Executive Director's Recommendation

Commission Meeting: March 7, 2019

PROJECT Rehabilitation of the Franklin School as a Home for Planet Word 925 13th Street, NW Washington, DC	NCPC FILE NUMBER 7932
	NCPC MAP FILE NUMBER 21.00(38.00)44867
SUBMITTED BY District of Columbia Office of the Deputy Mayor for Planning and Economic Development	APPLICANT'S REQUEST Approval of preliminary and final site and building plans
	PROPOSED ACTION Approve preliminary and final site and building plans
REVIEW AUTHORITY District Projects in the Central Area per 40 U.S.C. § 8722(b)(1) and (e)	ACTION ITEM TYPE Staff Presentation

Approval of Preliminary and Final Site and Building Plans

Closed Gate View from outside, on K Street

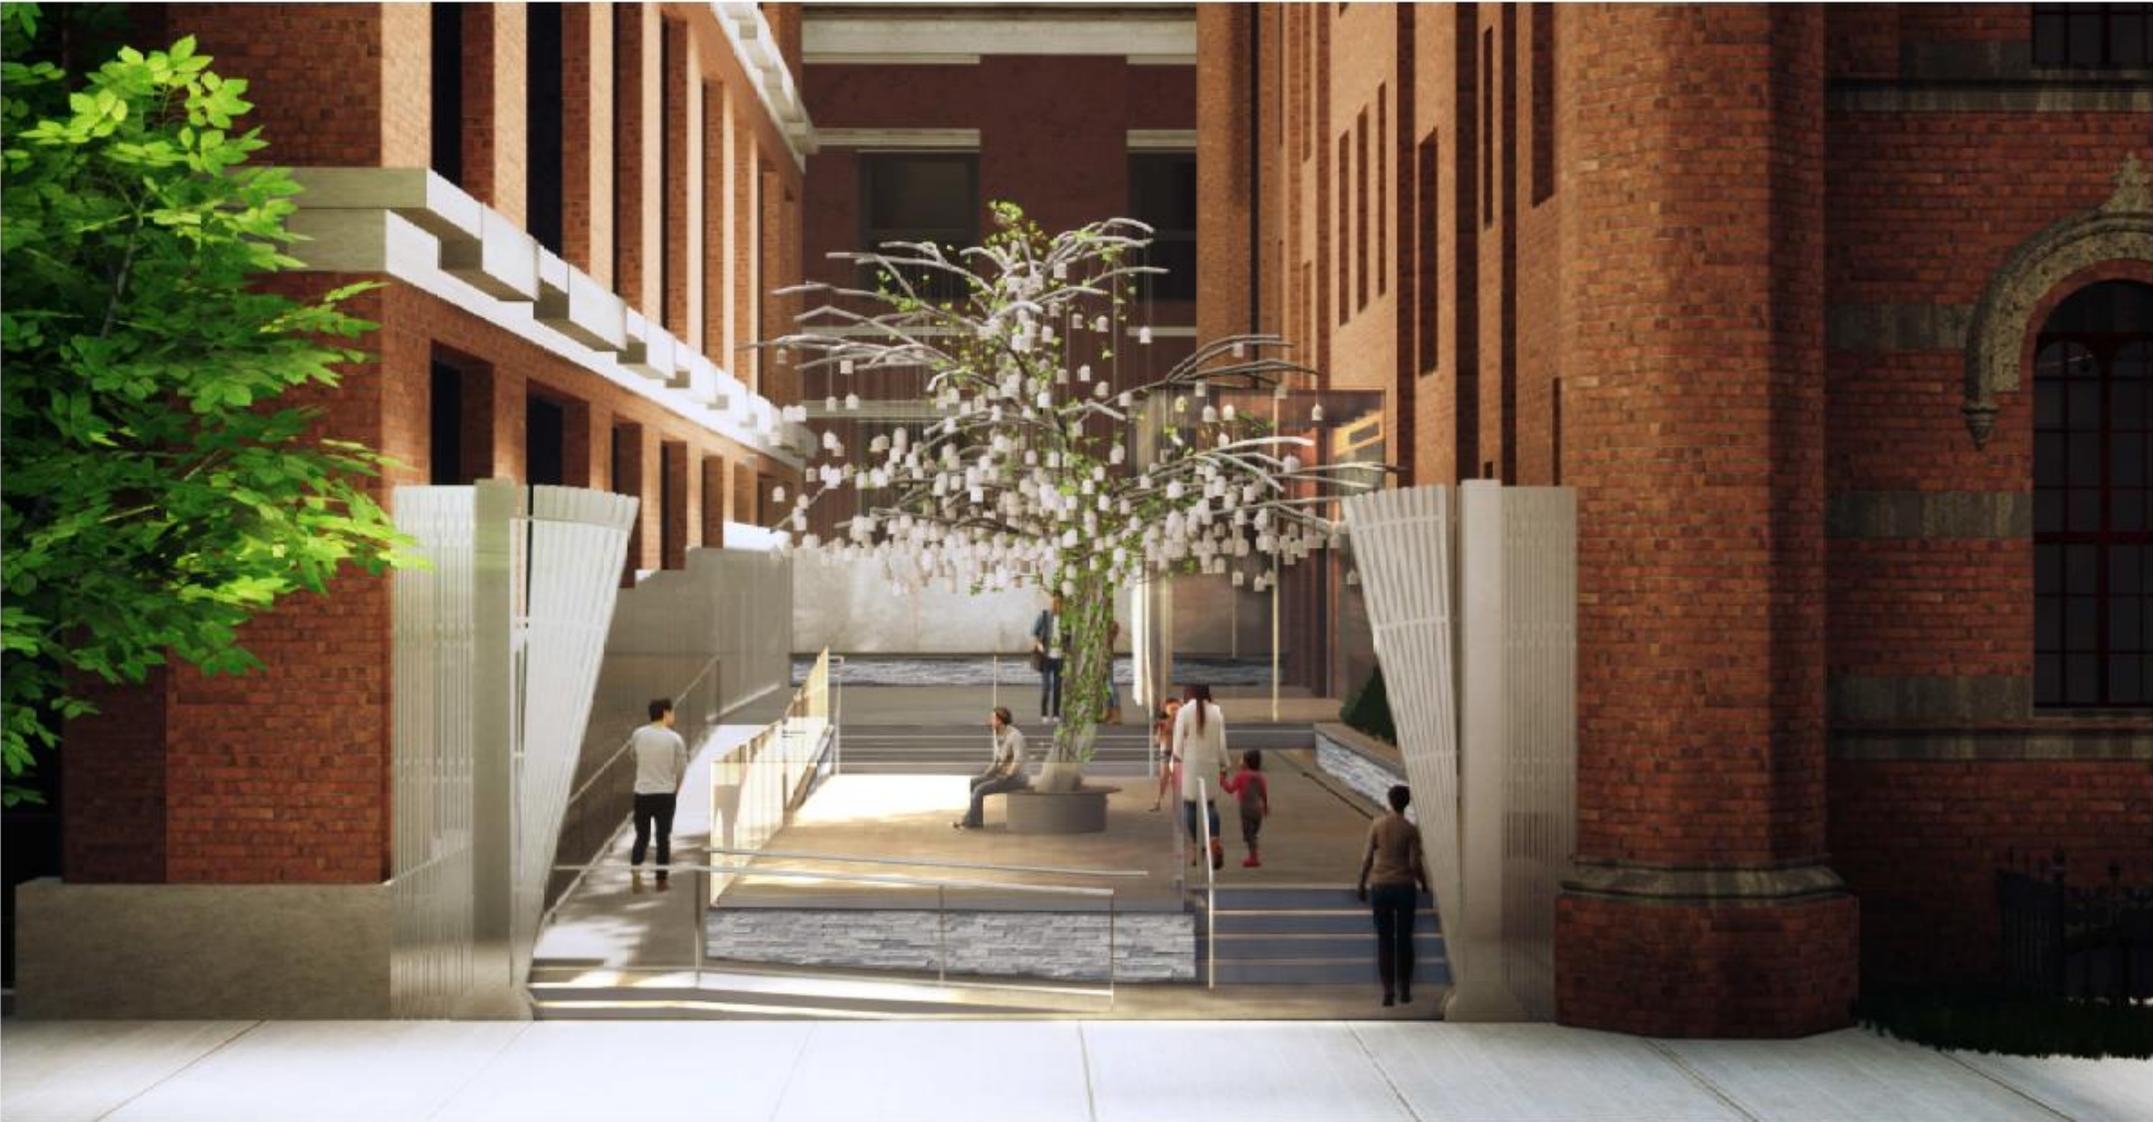
Notes the applicant has agreed to set the new entrance gate on K Street back approximately half a foot from the building wall so the gates do not read as part of the original historic composition.

Rendering of Corner of 13th Street and K Street Sign

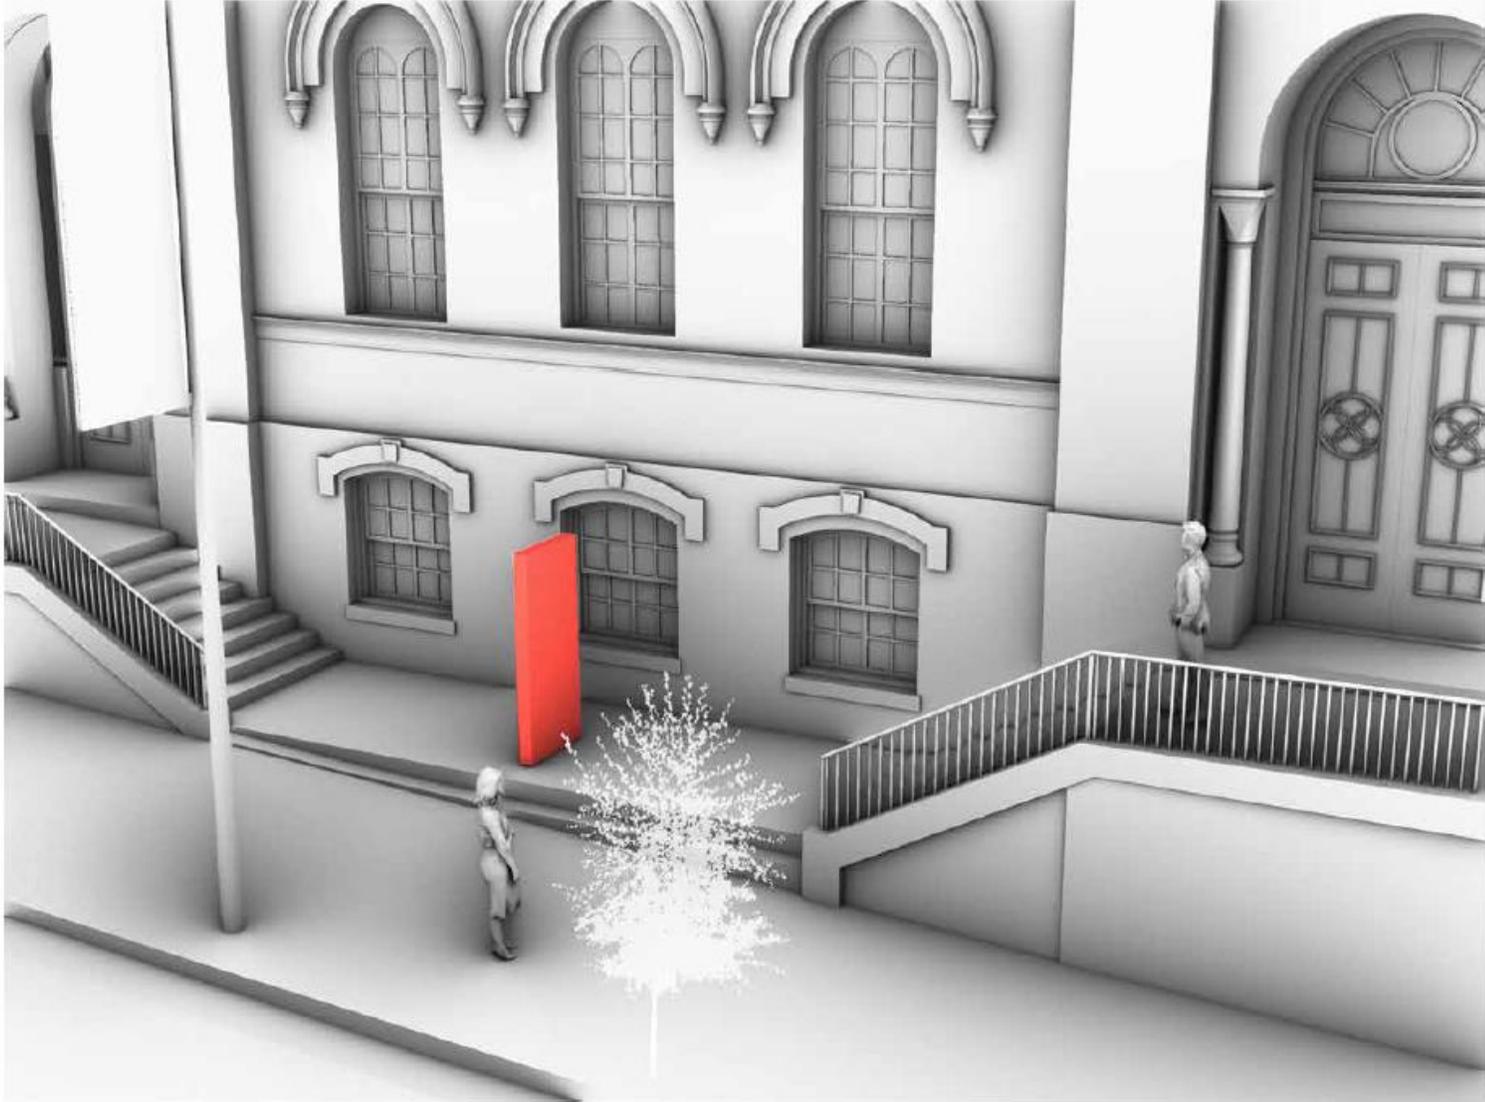
Requests that the applicant change the language on the monument sign at the bottom of the stairs on 13th Street from "enter on K Street" to "main (or primary) entrance on K Street" to indicate that the south stair entrance on 13th Street is still open for use.
